## CITY COUNCIL STAFF REPORT

**SUBJECT:** AN APPLICATION BY 750 LOFTS, LLC, OWNER, FOR DEVELOPMENT OF A 39-UNIT HOTEL WITH ACCESSORY USES ON A 1.13-ACRE PARCEL LOCATED AT 750 NORTH PALM CANYON DRIVE AND ADOPTING A MITIGATED NEGATIVE DECLARATION UNDER CEQA, ZONE C-1/R-3/PDD 104/RESORT COMBINING ZONE/LAS PALMAS BUSINESS HISTORIC DISTRICT HD-1, (CASE 5.1350 PDD 374/GPA/CUP/3.3795 MAJ).

**750 LOFTS**

**Planning Commission Comments: 6.24.15 Review**

**G-001.00**

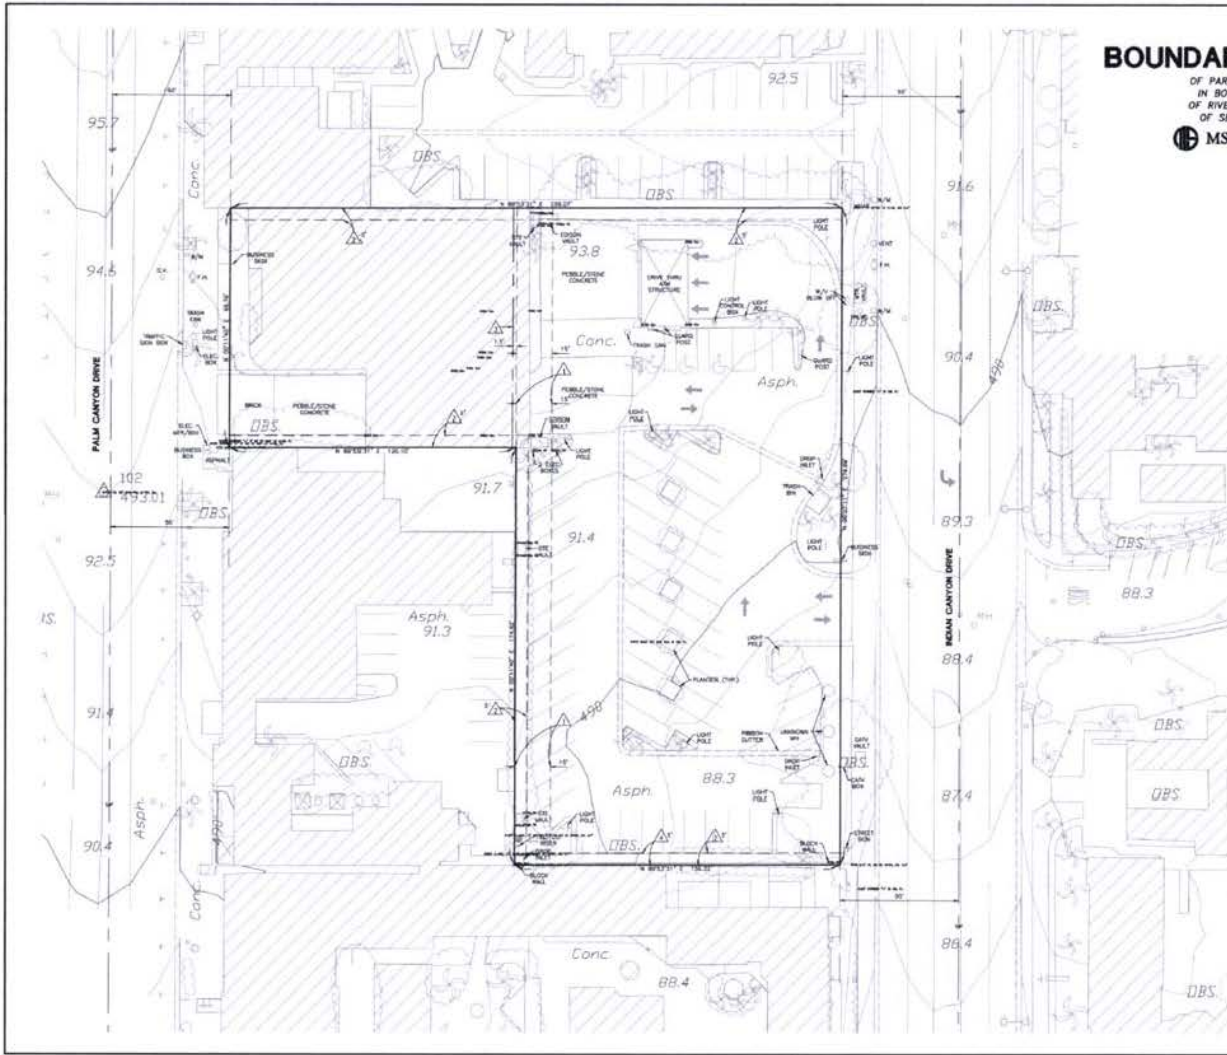
Response: The comment is incorrect. As shown on sheet G001.00 of the plan set, the views of the mountains are visible on the southern end of the property. On the north end of the property, sheet G001.00 shows that the peaks of the mountains are still visible. It is also important to note that the views of the mountains are partially obstructed from a direct head-on, stationary viewpoint. For the traveling public, for example, the partial obstruction occurs over the 275 foot length of the lot. Under current conditions, the Alcazar Hotel, located immediately south of the site, also limits views of the mountains to the west. Residents of the neighborhood to the east of Indian Canyon, which begins at a distance of over 250 feet east of the project site, will see above the proposed project, and will experience a loss of view of only the base of the mountains.

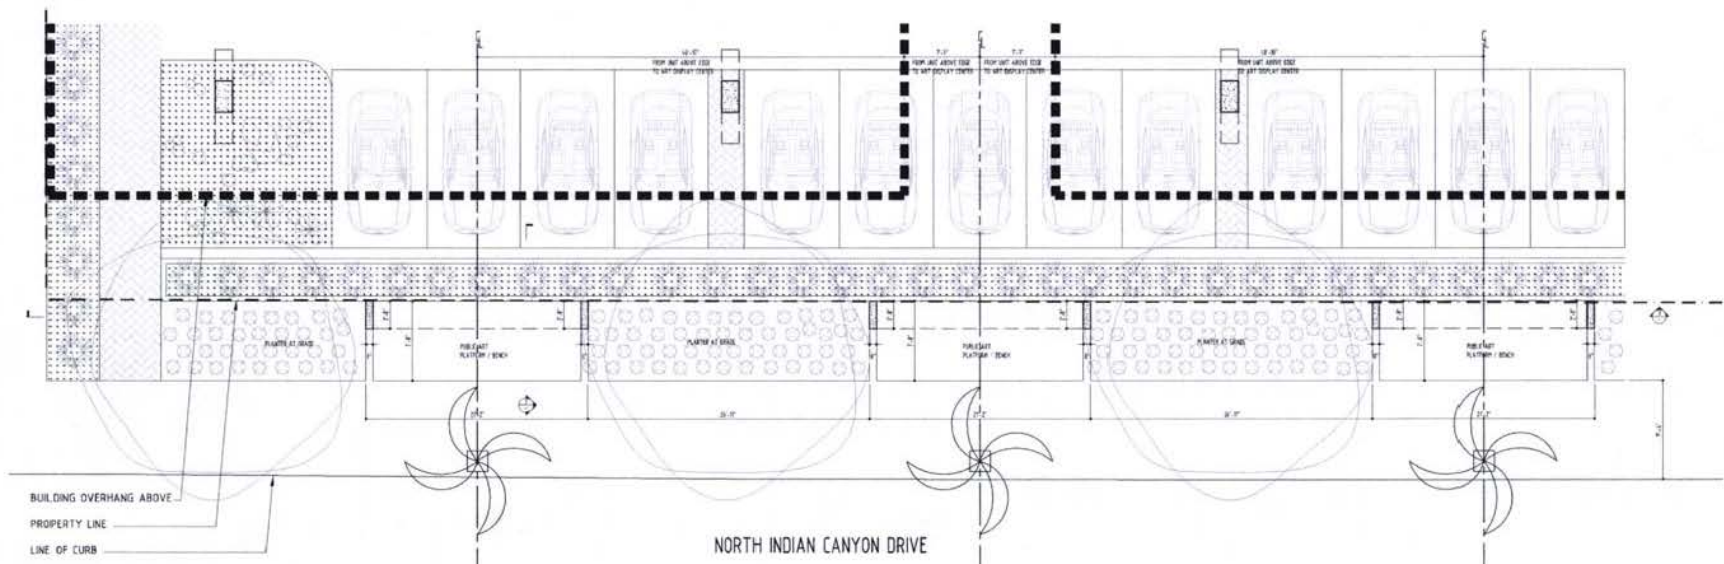
Item	Description	SOMA Response	Assigned
01	<p><b>Loading Space</b></p> <p>SOMA/Cioffi to look for potential curb cut on northeast alleyway into N. Indian Canyon Drive</p> <p>See SK-06</p>	<p><b>Per 93.07.01:</b></p> <p>Loading spaces shall be 12' x 30' x 14' clear height. (see diagram)</p> <p>Shall be designed so that trucks need not back into street or alley.*</p> <p>No part of street or alley shall be used for loading unless designated by City.</p> <p>Parking and drive areas may be used for loading spaces, if approved by Planning Commission.</p> <p><b>Option 1:</b> Provide 12' x 30' loading dock perpendicular to and backing in off of Indian Canyon Drive, which is contrary to code but worth trying* (see diagram).</p> <p><b>Option 2:</b> Provide 'timed' access off of Indian Canyon Drive into driveway and back into 12' x 30' loading dock parallel to the street (see diagram).</p>	KC
	See SK-06

02	<p><b>Curtains on Balconies</b></p> <p>SOMA to outline anchoring system to allay concerns</p>	Provide tension cable at base of curtain, with sst base to prevent potential tripping (see detail).	KC
	See SK-07		
03	<b>Art Walk Plan</b>		
04065	SOMA to create architectural details with Cioffi input.	Use proposed concrete frames along sidewalk and provide note that space within frame to contain changing exhibit for local artists.	MP
	See SK-05		
04	<b>Setback Issue from Street</b>		
05100	SOMA measurement from lot lines (east and west) to edge of pool deck and to rooftop building.	<p><b>General:</b> In PD Districts the regulations for front yard setbacks are per the underlying zoning districts, which is R-3 for the portion of site fronting Indian Canyon Drive and C-1 fronting Palm Canyon Drive. There is no regulation for setbacks above the roof. Here are the front yard setback requirements:</p> <p><b>R-3 District:</b> 30' front yard along major and secondary thoroughfares, Indian Canyon Drive (see diagram).</p> <p><b>C-1 District:</b> 5' front yard (see diagram).</p>	KC KC

See SK-04		
05	<b>Average Heights on Indian Canyon</b>		
	SOMA to provide average height on Indian (east) and Palm Canyon - use most favorable method.	<p><b>General:</b> In PD Districts the regulations for building heights are per the underlying zoning districts, which is R-3 for the portion of site fronting Indian Canyon Drive and C-1 fronting Palm Canyon Drive. Here are the building height requirements:</p>	DT

750 LOFTS			
Planning Commission Comments: 6.24.15 Review			
SOMA Response			July 2, 2015
Item	Description	SOMA Response	Assigned
		<p><b>R-3 District:</b> 24' height limit. Hotels shall be permitted 30' over a maximum of 50 percent of the ground floor area of all buildings and structures on site. Using the garage and public spaces located below the 2nd Floor Footprint on the R-3 portion of underlying district, the calculation is as follows: <math>17,254\text{sf} \times 0.5 = 8,627\text{sf}</math> at 30' (see diagram)</p> <p>24' height limit for 8,627sf (see diagram) 30' height limit for 8,627sf (see diagram)</p> <p><b>C-1 District:</b> 30' height limit (see diagram).</p>	
	See SK-08		
06	Open Space Calculation Including Roof Balcony		
	SOMA to provide calculations of total open space including roof deck open space.	<p><b>General:</b> In PD Districts the regulations for open space are per the underlying zoning districts, which is R-3 for the portion of site fronting Indian Canyon Drive and C-1 fronting Palm Canyon Drive. Here are the open space requirements:</p> <p><b>R-3 District:</b> Provide a minimum of 45 percent of the site area for usable landscaped open space and outdoor living and recreation space: <math>37,446 \times 0.45 = 16,851\text{sf}</math> of open space (see diagram)</p> <p><b>C-1 District:</b> No regulations for open space.</p>	DT
